### Agenda Item # 11

## AGENDA REPORT SUMMARY

**Subject:** 4880 El Camino Real—Elevator Tower Height Waiver

Elevator tower

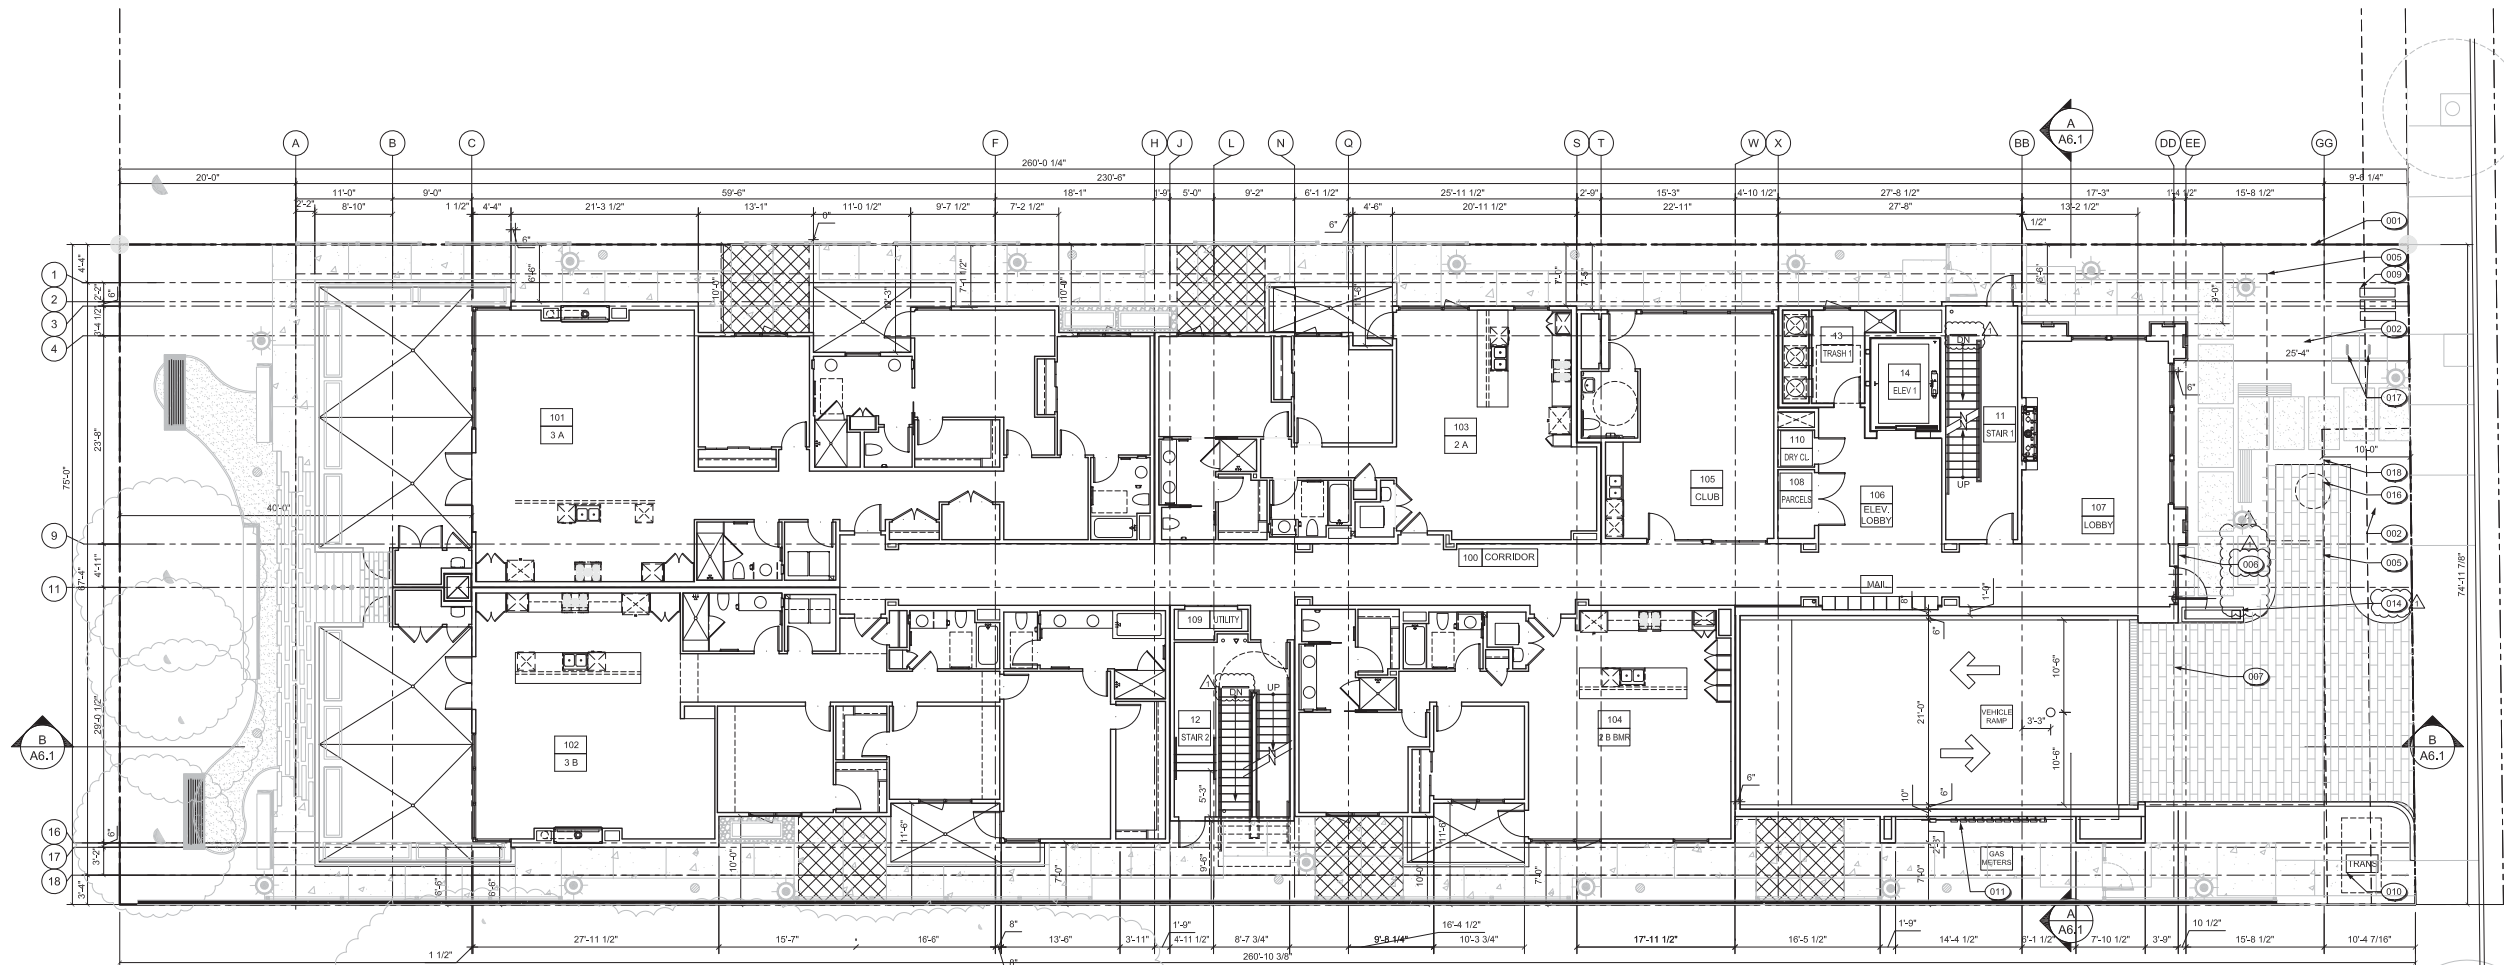
We also attach for your review some perspective studies showing what, if any, portion of the 15'-6" elevator shaft would be visible from several vantage points on El Camino Real. As you will see in the studies, the elevator shaft is hardly discernable given its location beyond the building's main facades. We believe that most people on the street will not be able to discern between a structure at 11 feet or at 15'-6".

**ELEVATOR SECTION**  
 1/4" = 1'-0"

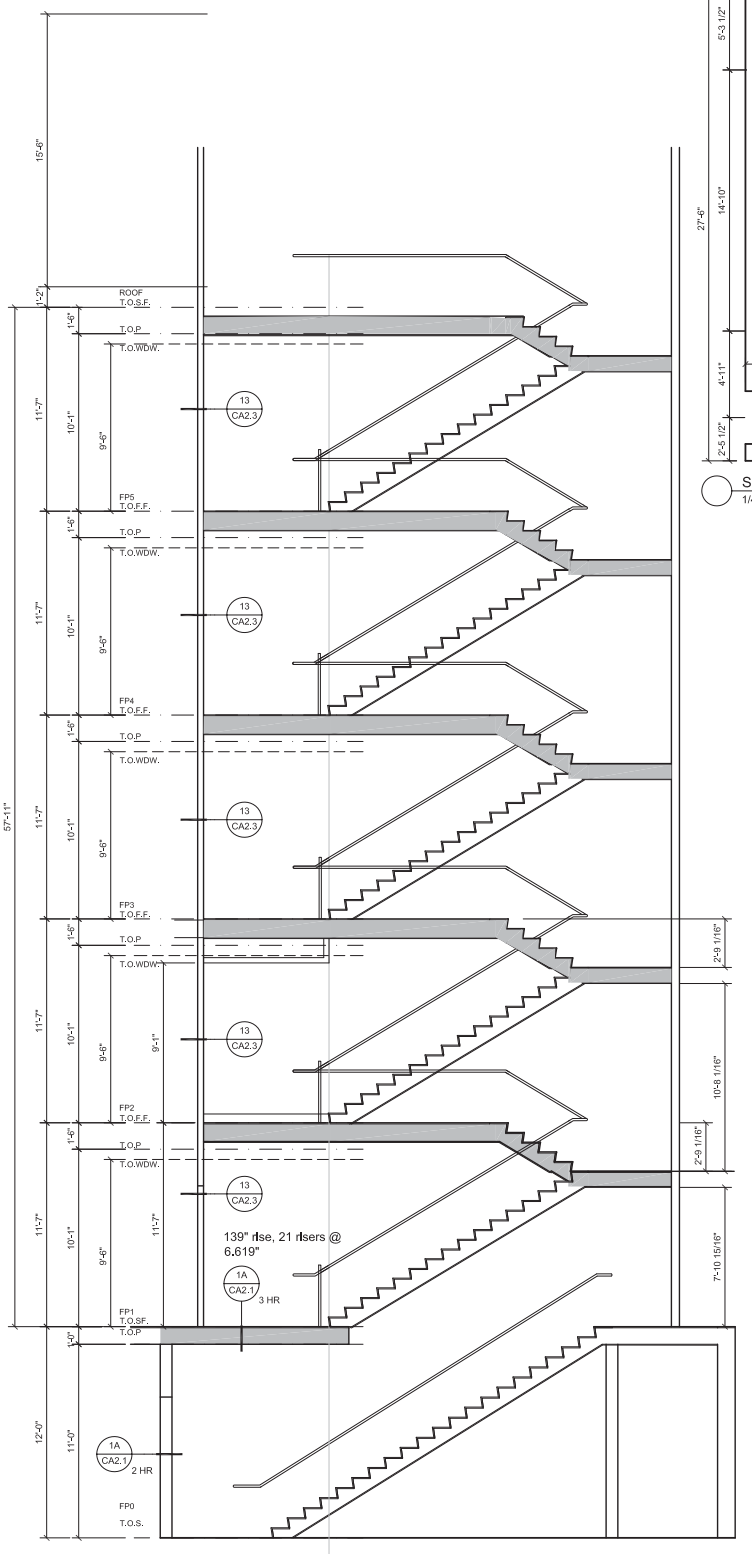
In developing the construction plans the applicant was unable to specify an appropriate elevator to serve the roof deck amenity within the granted 11-foot height limit above the structural roof deck. The applicant desires a nine-foot tall elevator cab, which is commensurate with the project’s 10-foot tall ceilings. When considering the manufacturer’s lowest required structure above the elevator cab, the elevator tower enclosure shows a height of 15.5 feet above the roof surface (or 6.5 feet above the elevator cab) is needed. The elevator tower’s height is set from the roof surface because that is the

The applicant provided cross-sections of the elevator design (see Sheet A4.2 of the Plans) showing the minimal head space above the elevator cab dictating the overall elevator height of 15.5 feet above the landing point. The applicant also provided three-dimensional graphics showing the visual effect of the taller elevator tower. The graphics show that the elevator tower would be visible from the street at distant vantage points.

The project approval is based upon the plans received on April 17, 2017, except as modified by these conditions. Such plans shall provide the rooftop elevator enclosure no higher than 16 feet eight inches above the structural roof deck, or 15.5 feet above the roof finish.
